SYDNEY SOUTH PLANNING PANEL - ASSESSMENT REPORT

Panel Reference	2019SSH009
DA Number	440/2018
LGA	Canterbury Bankstown Council
Proposed Development	Demolition of existing structures and construction of a four storey in-fill affordable housing development over a basement car park pursuant to the Affordable Rental Housing SEPP 2009
Street Address	71-83 Graham Road & 35-37 Karne Street South Narwee
Applicant/Owner	<u>Applicant:</u> Pavlakos Capital Pty Ltd (Mr. Constantine Pavlakos) <u>Owner/s:</u> Pavlakos Capital Pty Ltd, Evriklia and Constantine Pavlakos, Evangelo Pavlakos and George Pavlakos.
Date of DA lodgement	10 October 2018
Number of Submissions	Five (5) Submissions
Recommendation	Refusal
Regional Development Criteria (Schedule 7 of the SEPP (State and Regional Development) 2011	Part 4, Clause 20(1) of the SEPP (State and Regional Development) 2011 the application is declared as regionally significant development. Schedule 7 includes 'Private infrastructure and community facilities over \$5 million. The proposal has a capital investment value of \$10,685,425.00 and provides affordable housing and therefore falls within this category.

Development Application No. DA-440/2018

Figure 5 Streetscape Analysis

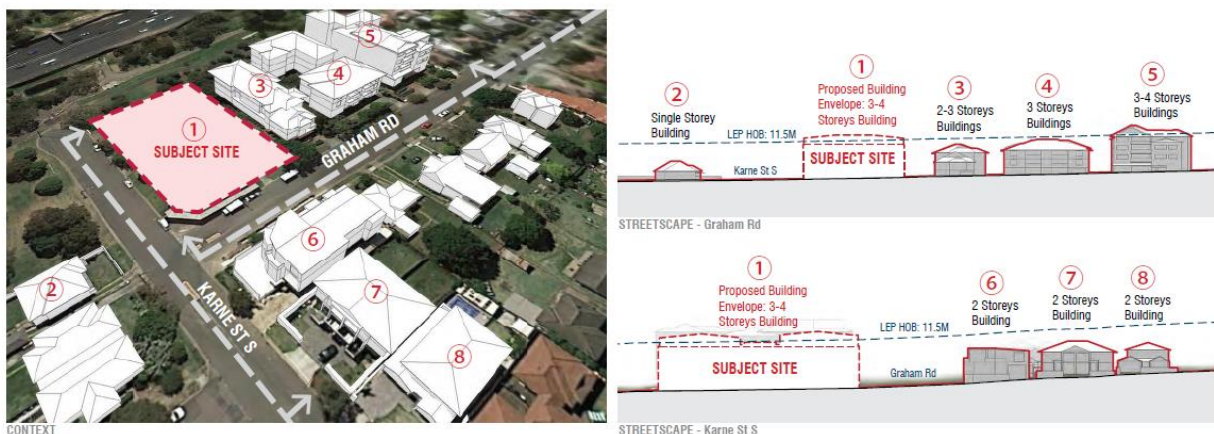
It should be noted that 59-61 Graham Road and 25-27 Graham Road are four-storey residential flat buildings only by virtue of ground level garages and were developments approved prior to 2012 under different planning controls which did not have building height controls. The development at 19-23 Graham Road (marked as 10 in the figure 5 above) was approved by the NSW Government as part of the NSW Nation Building and Jobs Plan Taskforce in 2009.

Consideration should also be given to the context of the area and the desired future character, that are set by the objectives and controls of the Canterbury Local Environmental Plan 2012 (CLEP 2012) and Part C4 Residential Flat Buildings of the Canterbury Development Control Plan 2012 (CDCP 12012).

The height is shown in the section view below.

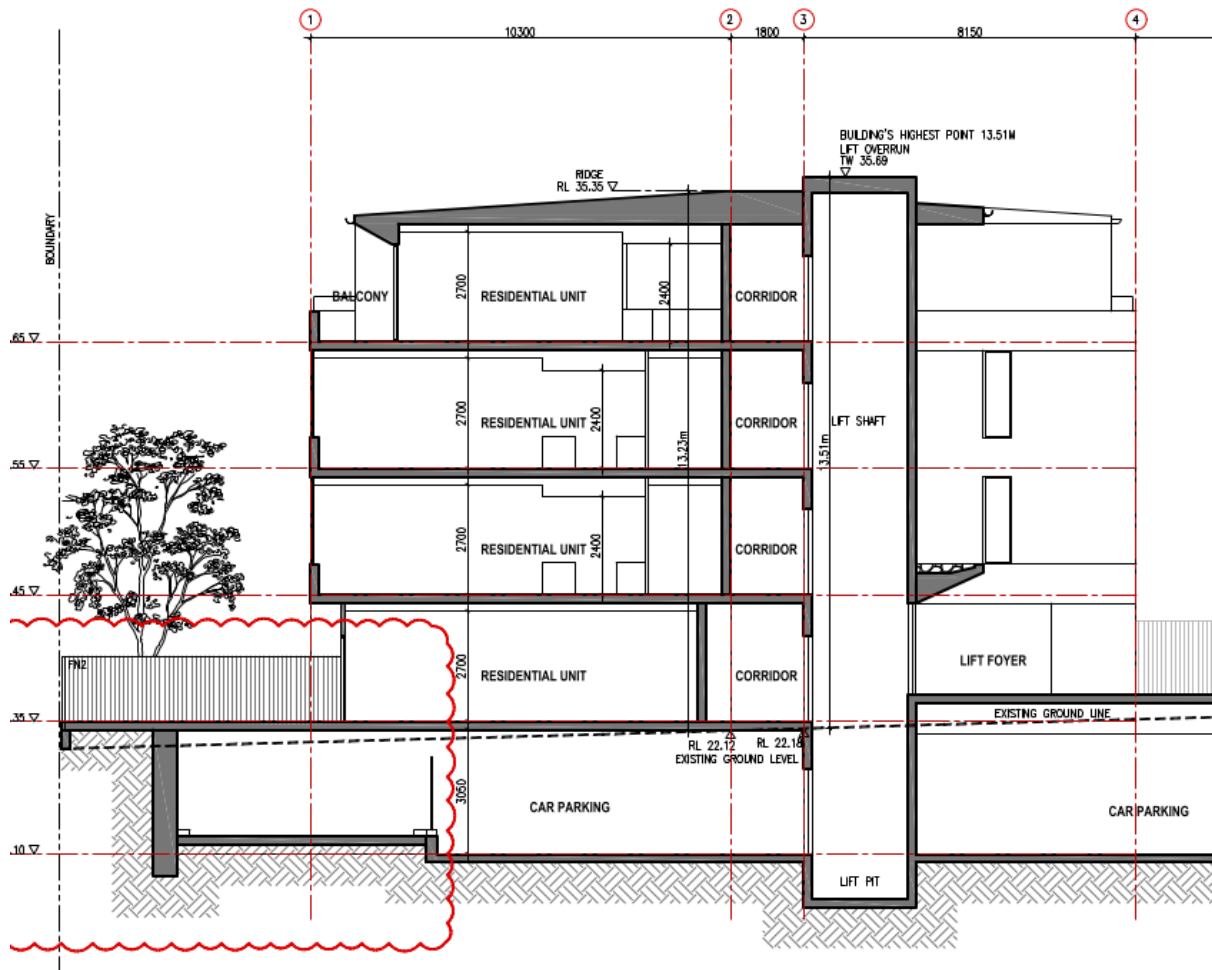
The variation to the portion of building to the north of the site (closest to the park) ranges from 1.73m -2.01m.

15.04%-17.5% degree of variation.

On this basis, there are insufficient environmental planning grounds to justify the contravention of the development standard, relating to the building height.

With regard to the above, it is considered that the applicant's written submission under Clause 4.6 of CLEP 2012 to vary the building height is not well-founded and it has not been adequately demonstrated that compliance with the development standard is unreasonable or unnecessary in the circumstances of the case. The submission has not provided sufficient environmental planning grounds to justify the contravention to the building height.
